Land Use Final Decision Type I Staff Report

File number(s): DR 23-07

Project name: Woodburn Evangelical Church Kitchen Addition

Date of decision: May 8, 2024

Exhibit A. Site Plan Sheet A1.1. Dated 5/7/24

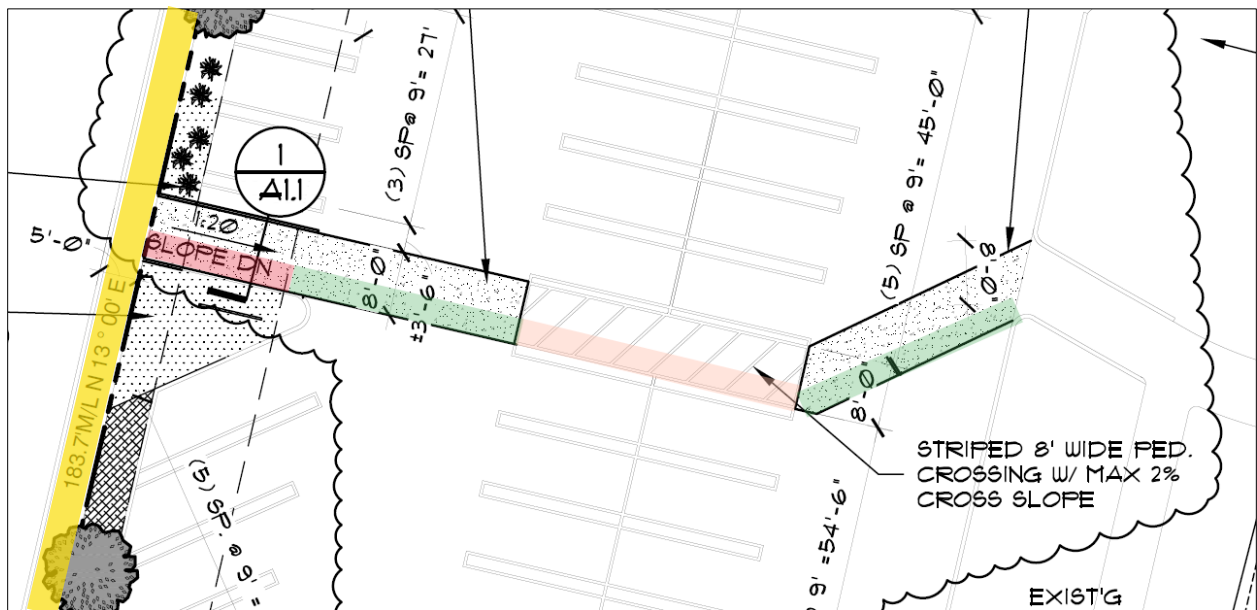
D2. Wide walkway: To conform with WDO 3.04.06, substantially as illustrated on land use review site plans, there shall be a wide walkway minimum width 8 feet connecting the building main entrance and sidewalk and to the standards of 3.04.06D.1 by building permit inspection. (See submitted conceptual Exhibit A below.)

Exhibit A. Site Plan Sheet A1.1. Dated 5/7/24

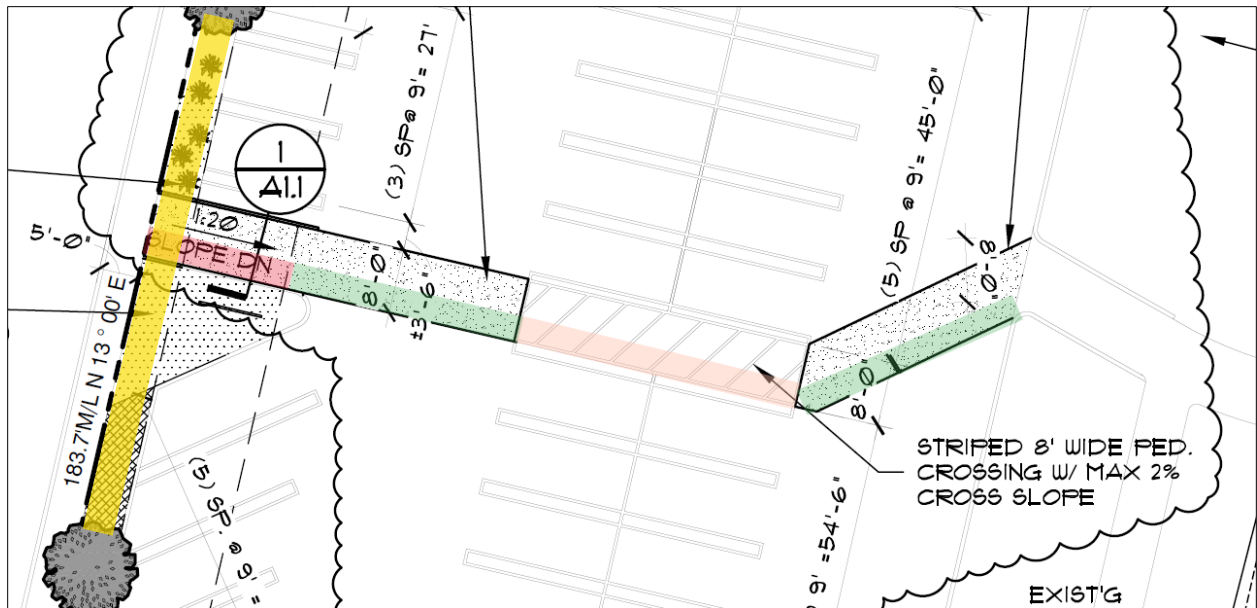
Submitted plans meet this requirement to provide a wide walkway connection between the building and the existing sidewalk (illustrated below in color).

Staff applies a condition to ensure conformance with this requirement. The applicant must provide a site plan showing an ADA-compliant ramp with walkway plans before building permit issuance.
